**CITY OF SAINT PAUL
HERITAGE PRESERVATION COMMISSION STAFF REPORT**

FILE NAME: 574 Summit Avenue
DATE OF APPLICATION: July 2, 2015 (with final revised plans submitted March 24, 2016)
APPLICANT: Charles Stander
OWNER: same
DATE OF PUBLIC HEARING: April 14, 2016
HPC SITE/DISTRICT: Historic Hill Heritage Preservation District
CATEGORY: Pivotal
CLASSIFICATION: Building Permit #15-155889
STAFF INVESTIGATION AND REPORT: Amy Spong, Fred Counts
DATE: April 8, 2016

NORTH ELEVATION

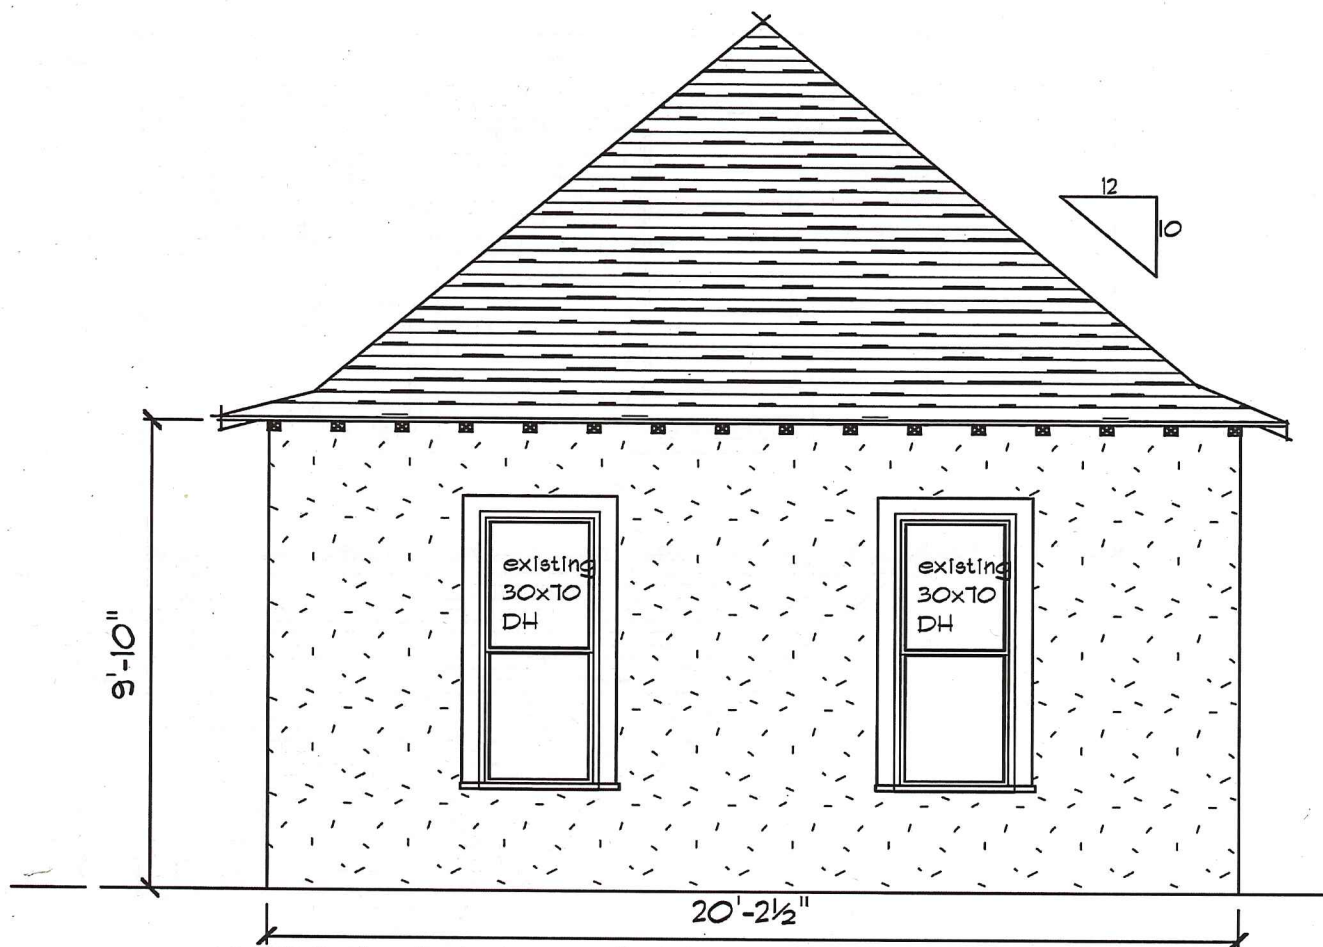
6. **§74.64.(a)(10).** The new addition is not connected in a way that if “removed in the future, the essential form and integrity of the structure would be unimpaired.” The south elevation has an almost 4' setback from the existing wall and the existing roof ridge is still intact, but the north elevation does not have a setback or reveal from the original north wall and roof ridge. This standard is not met as there isn't a clear differentiation on the north elevation distinguishing original from new. The brick wainscoting on the new addition is one way to distinguish old from new.

7. **§74.65 New Construction.** The proposed addition complies with the guidelines for massing and height, materials, roofs, setback, and windows and doors. The detail of the new front (north) wall which continues the historic garage wall and roof plane does not meet the

guideline to preserve the overall size, shape and form of the early auto garage.

1. The north (front-facing) elevation of the new addition shall be set back (shifted) an appropriate distance to preserve the corner and roof ridge of the historic garage. A revised design shall be submitted to staff for final review and approval prior to permit issuance.
